## **WYNNFIELD SUBDIVISION UNIT FIVE**

APPLICATION NUMBER 18 DATE March 17, 2005  
APPLICANT Wynnfield Subdivision, Unit Five  
REQUEST Subdivision

# DETAIL SITE PLAN

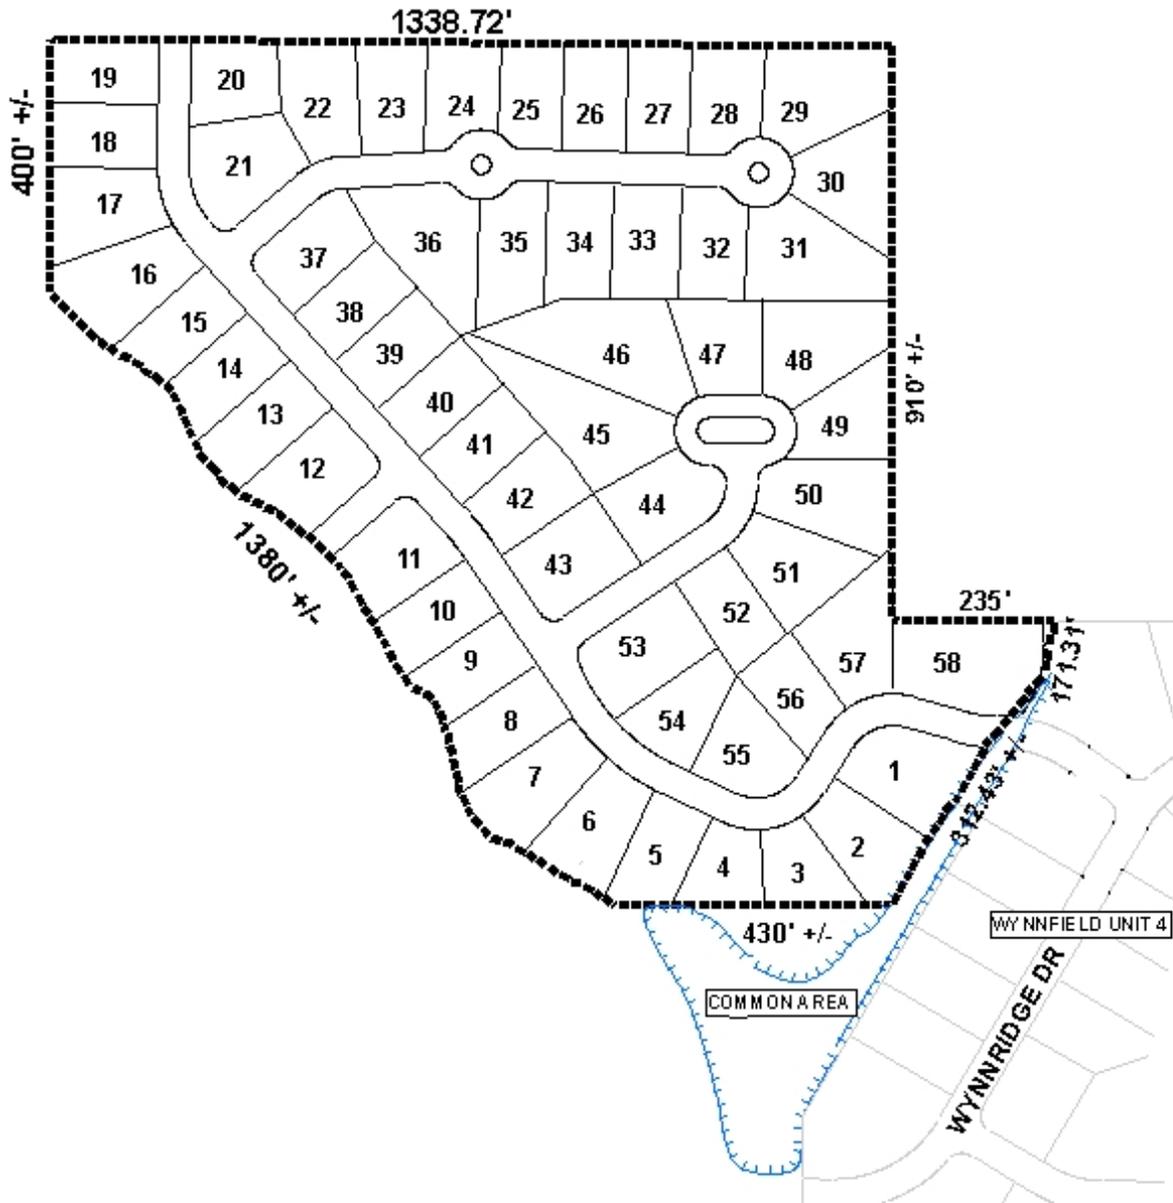
The 25-foot minimum building setback line from the right-of-way edge is not shown (though it is noted on the plat) but would be required on the Final Plat, if approved.

A tributary to Halls Mill Creek forms the southwestern boundary of the proposed subdivision. Aerial photographs indicate the possibility of wetlands in association with the tributary. Wetlands may also occur in association with the tributary that includes the existing stormwater detention area near lots 1-5 and 58. The potential presence of wetlands, in addition to the creek,

indicate that the area may be environmentally sensitive; therefore, the approval of all applicable federal, state and local agencies would be required prior to the issuance of any permits.

A parcel outside of the proposed subdivision and adjacent to proposed lots 29-31 and 48-49 is land-locked, and access to this parcel is not proposed. Future access to the land-locked parcel in question would then be limited to other currently land-locked parcels to the north. Therefore, it should be required that either a right-of-way stub or a 25-foot wide frontage onto a street of the proposed subdivision be provided to the landlocked parcel east of lots 29-31 and 48-49, in the area of one of the aforementioned lots.

Based upon the proceeding, the plat is recommended for Holdover for the following reasons: 1) the submission of a revised plat to include all parcels that are part of the subdivision request, as well as any additional property-owner notification information; and 2) the redesign of the proposed subdivision to provide access to the land-locked parcel to the east of the proposed subdivision.
